Improving the CR loss budget

Piers Dawe, Nvidia

Comment 92, improve the CR loss allocations

Example of switch PCB losses

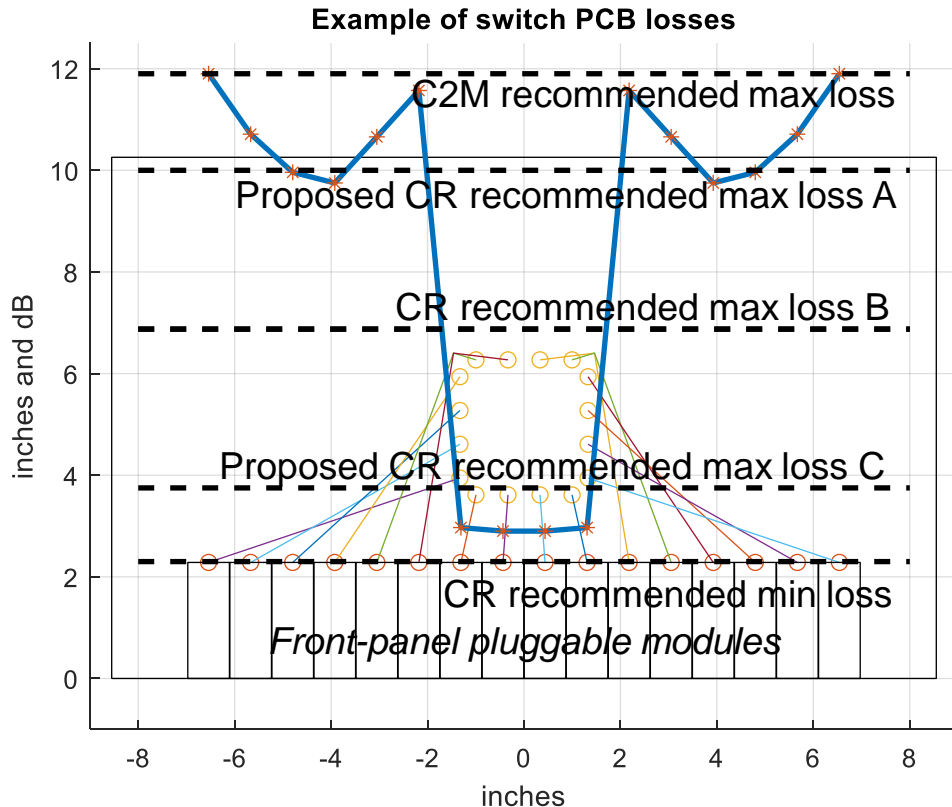
6.875/2.3 = 3:1 is too small a max/min loss ratio anyway

- In this example, all paths are below the C2M recommended max loss (good)
- But only 8 out of 32 are within the CR recommended max loss (bad)
- Other distributions are possible (see next slide) but the issue remains
- There are fixes (see e.g. [2]) but with costs

Another example of switch PCB losses

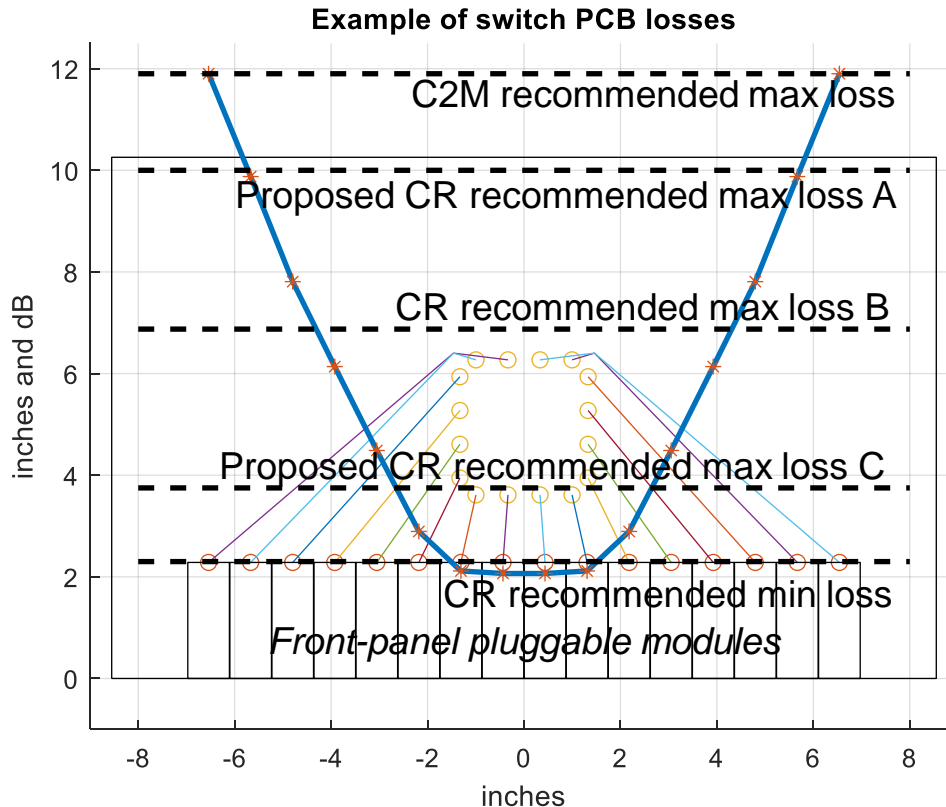
6.875/2.3 = 3:1 is too small a max/min loss ratio anyway

- In this example, all paths are below the C2M recommended max loss but it needs lower loss/in than previous example
- But only 10 out of 32 are within the CR recommended max loss (bad)
- 4 paths are below the C2M recommended minimum
- There are fixes (see e.g. [2]) but with costs

Figure 162A-3—Cable assembly, host, and test fixture insertion loss at 26.56 GHz

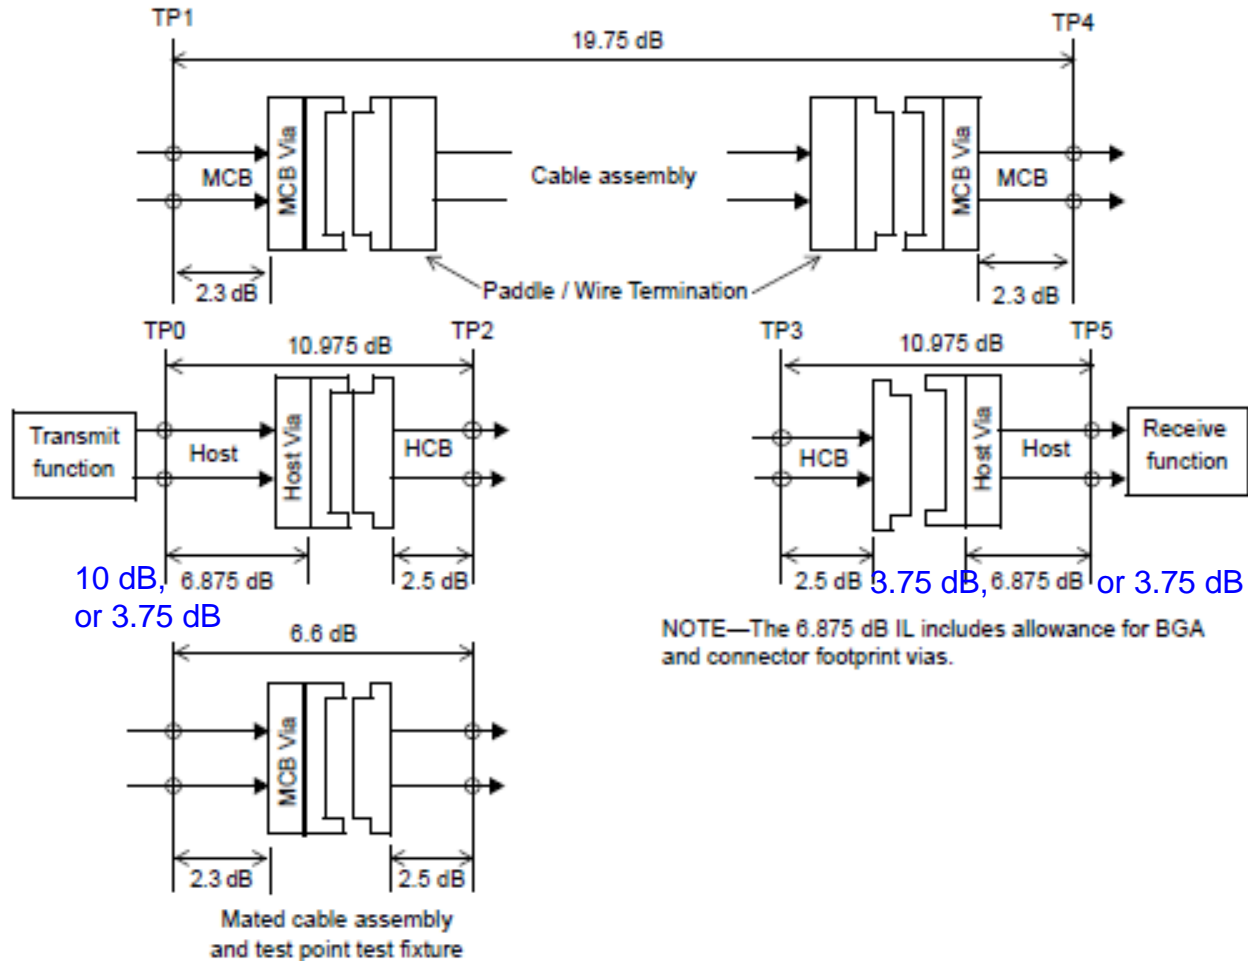
- In Table 162-10, add limits A and C for linear fit pulse peak ratio (min), as in next slide
 - Change text in 162.9.3.1.2 to refer to the table
- In Table 162-15, add columns for Test 2 (high loss), A and C, with test channel insertion loss:
 - A: $6.875 - 3.75 = 3.125$ dB lower (20.5 dB to 21.5 dB), and
 - C: $10 - 6.875 = 3.125$ dB higher (26.75 dB to 27.75 dB), as in slide after next
 - No change needed for Test 1 (low loss)
- In 162A.4, add equations for IL_PCBmax and ILHostMax A and C, show them in Fig 162A-1 and 2
- In 162A.5, add Value columns A, C in Table 162A-1 (ILChmin and ILMaxHost differ)
- Adjust figures 162A-3 and 4.

Figure 162A-4—Channel insertion loss at 26.56 GHz

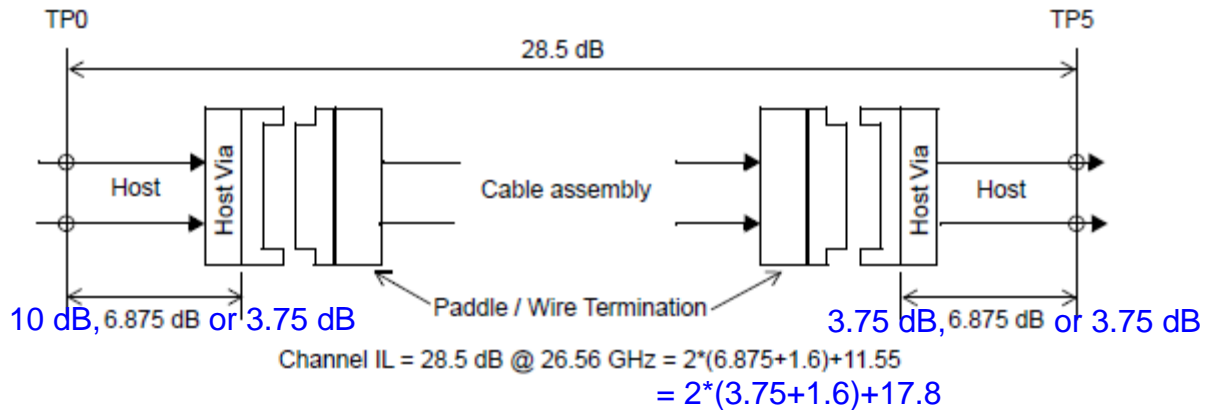
- 2 classes of cable, which could be called "short" (19.75 dB, as today) and "long", $19.75 + 2 * (6.875 - 3.75) = 19.75 + 6.25 = 26$ dB max (achievable cable length 3 m). Long cables connect port types C (see another comment) at both ends, short cables connect a valid combination of A, B, C.
- In 162.11.2, cable assembly insertion loss, change text to refer to Table 162-17.
- In 162.11.7.1.1, add $z_p = 30.7$ mm for the "short" cable.
- In Table 162A-1, add a column for the A-short-A scenario (ILCamax differs).
- Illustrate in Figure 162A-4.

- 2 classes of cable, "short" or regular (19.75 dB, as today) and "long", $19.75 + 2 * (6.875 - 3.75) = 19.75 + 6.25 = 26$ dB max
 - Achievable cable length 3 m
 - A B C hosts could enable a "super short" category too, $19.75 - 6.25 = 13.5$ dB max for A-A links, and intermediate categories: assume that these are not interesting
- Long cables connect port types C at both ends, short cables connect a valid (see earlier) combination of A, B, C
 - Each host knows its loss ability, learns remote loss ability from AN, learns cable loss class from its memory map
- In 162.11.2, cable assembly insertion loss, change text to refer to Table 162-17
- In 162.11.7.1.1, add $z_p = 30.7$ mm for the "short" cable
- In Table 162A-1, add a column for the A-short-A scenario (ILCamax differs) as on next slide
- Figure 162A-3 stays as slide 19, Figure 162A-4 as on slide 24
